Bike paths should not align with major roads and arterials around and over Cooper Mountain

Figure 8 - Concept Plan Bicycle & Pedestrian Framework

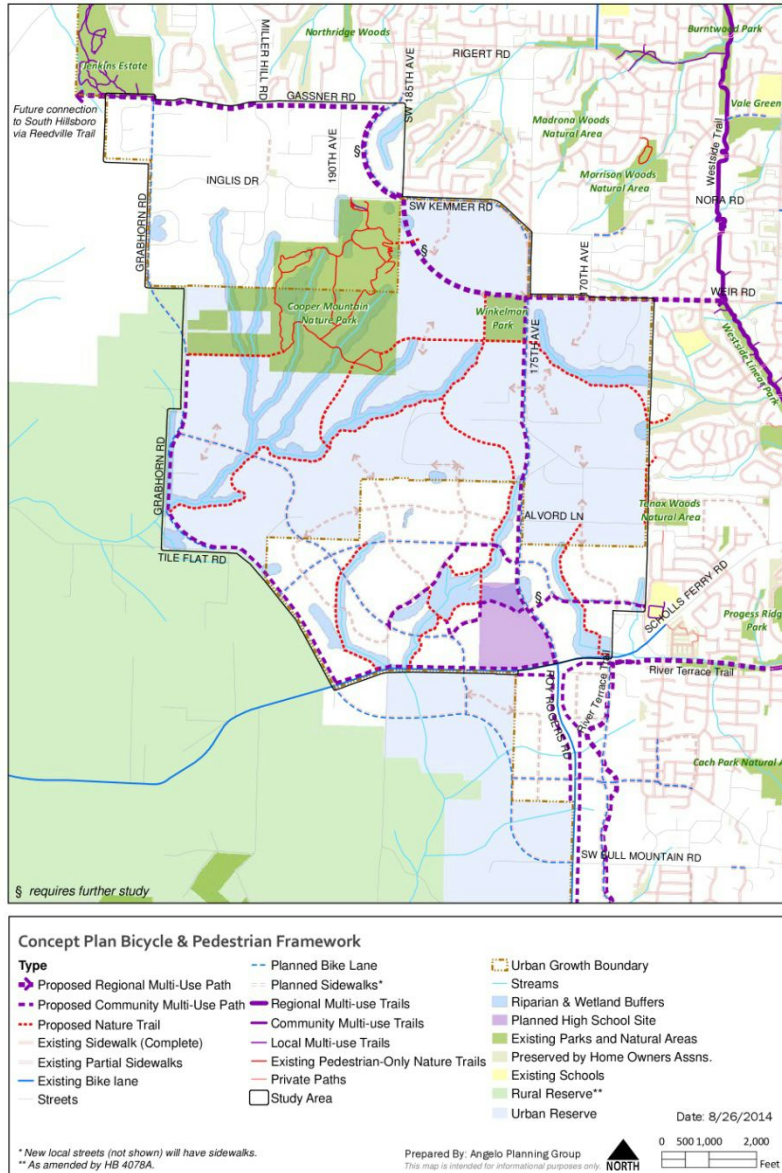
1. In the South Cooper Mountain area there is a planned multiuse path and bike lane:
 - a. Running along 175th Ave north from Scholls Ferry to at least Winkelman Park and beyond.

- b. Running west from 175th & Roy Rogers along Scholls Ferry / Tile Flat / Grabhorn.
2. Putting a bike lane along a major interurban or rural arterial just adds multiple incompatible modes of transportation to an existing road.

- a. Why is that necessary?
 - b. I would like to push back on the assumptions that got us to this point.
3. I propose that we look at completely separating these incompatible transportation modes:

- a. There are planned nature trails all over upper Cooper Mountain.
 - b. If you add bikes to the trails you keep the bikes separated from the high traffic on the roads.

- c. It is proven that bikes and pedestrians on trails can coexist.
 - d. The cost of a 5-10 foot wide trail is much less than the equivalent width of a highly developed road that satisfies multiple “industry standards” and codes.

- e. It preserves the challenge for the bikers who currently climb up Cooper Mountain and keeps them safer than tangling with semi trucks and the greatly increased traffic.

- f. These road segments are in the Urban Reserve area and have a very long time horizon for improvements and moving the bikes off of them could be done sooner due to lower cost:

- i. 175th at the top of Cooper Mountain
 - ii. West end of Tile Flat
 - iii. Grabhorn
4. Summary
 - a. There are safety issues with forcing bicycles to ride along major thoroughfares, particularly when different segments of the arterial will be improved at different times (175th in SCM vs. 175th in Urban Reserve areas). Let’s find a way to separate them onto the trails that will cover Cooper Mountain.

- b. The Regional Multi-Use Path (Metro-funded?) is going along the roads but Beaverton should be using these funds to convert one or two of the Nature Trails (red dotted lines) or the Community Multi-Use Trails (purple dotted lines) to a N-S Regional Multi-Use Trail (Metro-funded?) which will then fan out at the top of the hill to end at the ideal destinations – thus avoiding the major roads and arterials.

- c. Bicyclists can still get to desired destinations using safer, more interesting routes.
